# Aquatic Facility Audit

AQ1-0224-DR1, Revision A

## Cleveland Aquatic Centre

**REDLAND CITY COUNCIL**

Figure 4: Failed tiling in gutter floor

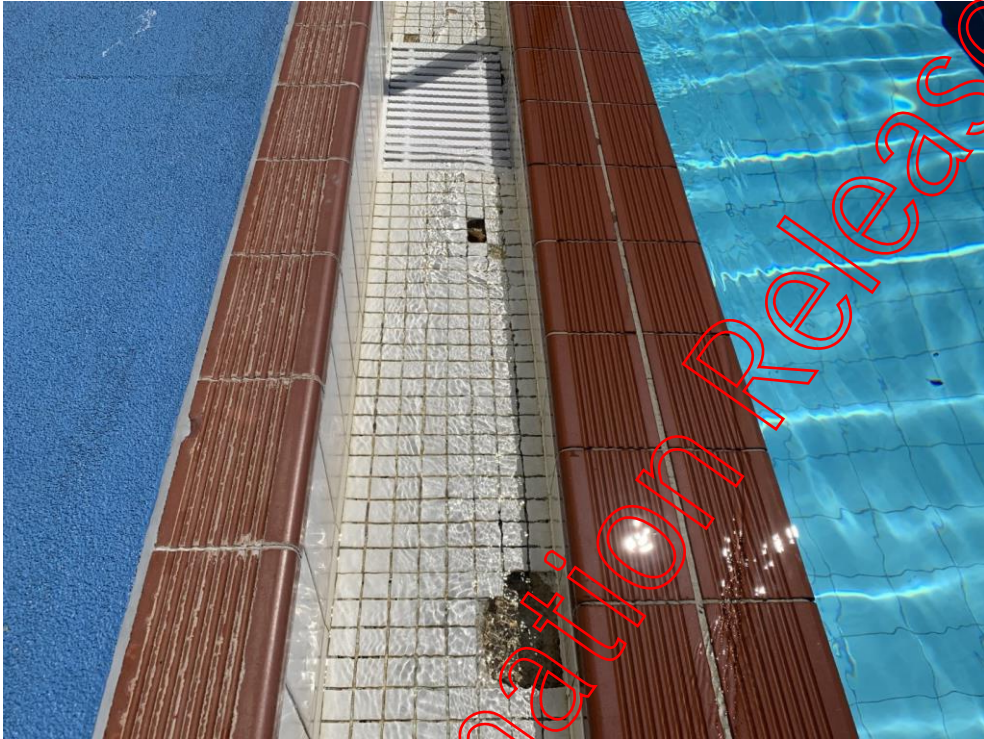
- Tiling in the wet deck gutters is failing in places.
- The tiling in the floor of the pool is not slip-resistant. Activities in the pool that require friction to the floor (such as aqua-aerobics, LTS and the like) have an increased risk of injury if slip resistant finishes are not utilized.

- Undertake a survey of the pool wall levels and repeat in 12 months to determine if there is any movement.
- Replace the tank lids with lighter lockable items such as Terra Firma lids.
- Rectify failed tiling. Undertake a detailed grout inspection on the pool and repair / replace as necessary.
- Consult with operational staff regarding floor tiling slip level and identification of any operational issues experienced.
- Consider providing grated covers to the open channel wet decks.
- Undertake circulation dye testing in accordance with the Model Aquatic Health Code. If dead spots are identified, improvements may be required to the filtered water return system.

Figure 6: Steps into pool over gutter presenting injury risk

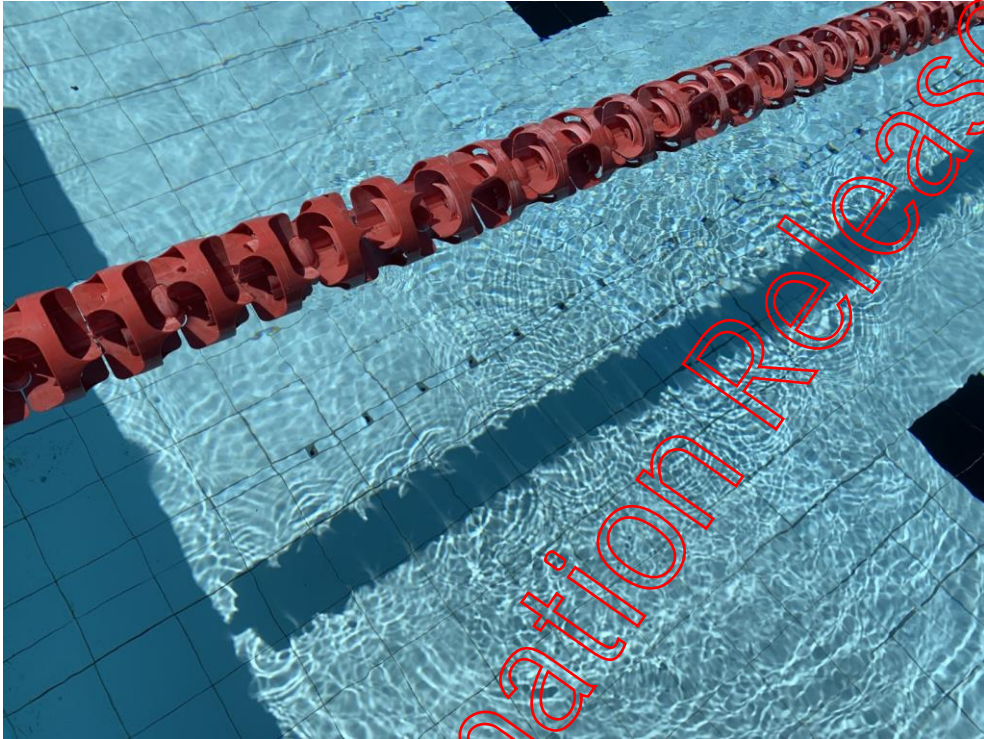
- The gutter design is outdated, presenting as an open channel to the full length with pool access over this channel. This presents a risk of ankle injury and falls/trips.

*Figure 11: Cloudy water, poor access across end of pool*

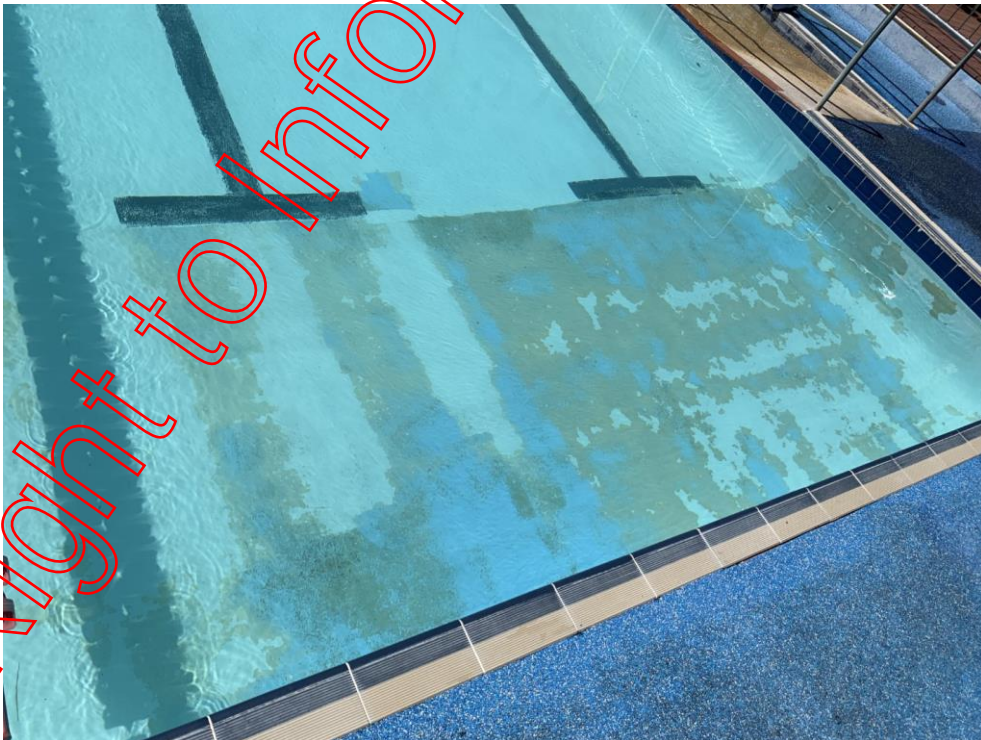
- At the time of the inspection, the pool was very cloudy. This is a reported problem by the operators, with indications that the painted internal finish is failing. This paint failure is observed in particular areas of the pool, where the finish has severely degraded and the underlying structure is visible, indicating poor installation techniques in these areas.
- Flow through the pool appears to be very low. Water ebbs into the skimmers whereas it would usually have a visible flow.
- None of the skimmers are fitted with strainer baskets, which can result in pipework blockages.
- None of the filtered water returns to the pool have a fitting such as an eyeball present. Instead, open pipes are present in the pool which could become a hand entrapment.

- Access around the pool does not comply with Royal Lifesaving Guidelines for Safe Pool Operation (min 1000mm for low traffic areas, min 3000mm for high traffic areas).
- A crack was observed in the pool wall at the upper level. This crack appears minor, however the fiberglass liner makes observation of other structural issues difficult.

- The painted finish in the pool is at the end of life and requires replacement, noting that also the fiberglass liner below the pool may be problematic due to its age. A higher-level approach towards the pool finish is required as discussed in the *Conclusions* section.
- The low flow through the filtration system is impacted by several factors, including the pipework, plant and pool fittings. This is discussed further in the *25m Filtration Plant* section.
- Provide strainer baskets to the skimmers.
- Provide eyeball fittings to the outlets.
- Review access in and around the pool and apply a risk assessment to mitigate movement and access risks.
- If the liner is to be removed, undertake a detailed structural assessment of the underlying structure.

Figure 29: Crack across pool floor on eastern side

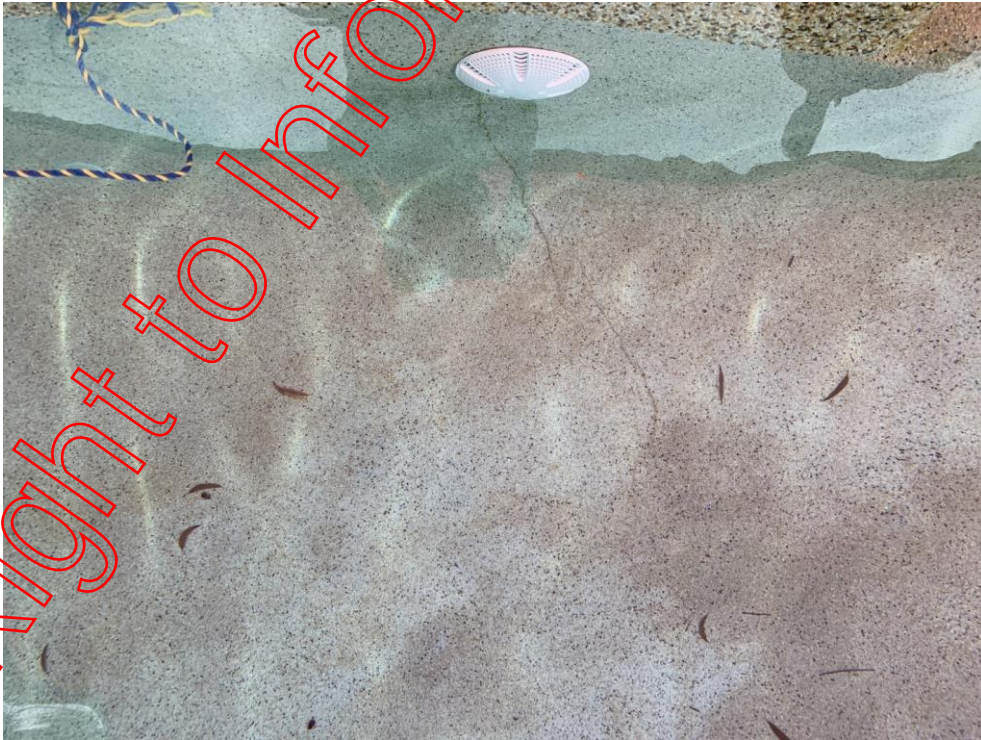
- Cracks are observed in the pool structure. The majority of the cracks appear to be relatively minor cracks at the tops of the walls likely a result of under-reinforcement in the coping, however one larger crack appears to continue across the entire pool at the waterslide landing zone region.

*Figure 118: Inadequate pipe supports in filter manifold*

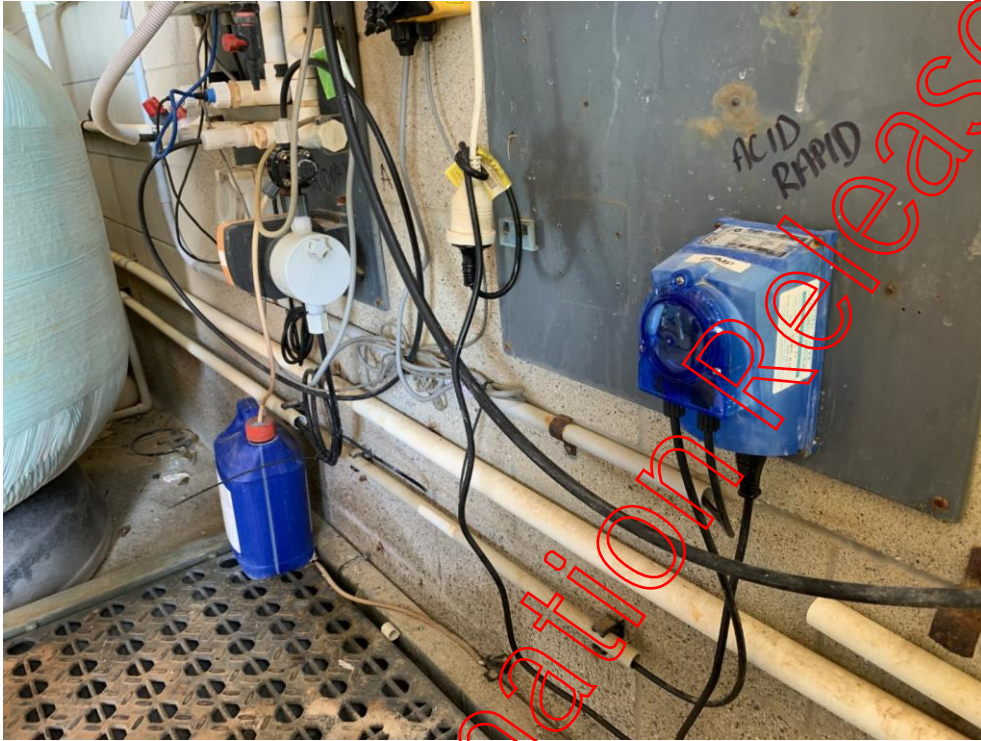
- Pipework support is inadequate, with filter manifolds practically unsupported.
- No positive ventilation system is present to the plant room. Many items inside are corroded.

- Provide pipework supports in accordance with pipe supplier instructions so that no load is placed on equipment from pipework.
- Provide a mechanical ventilation system.
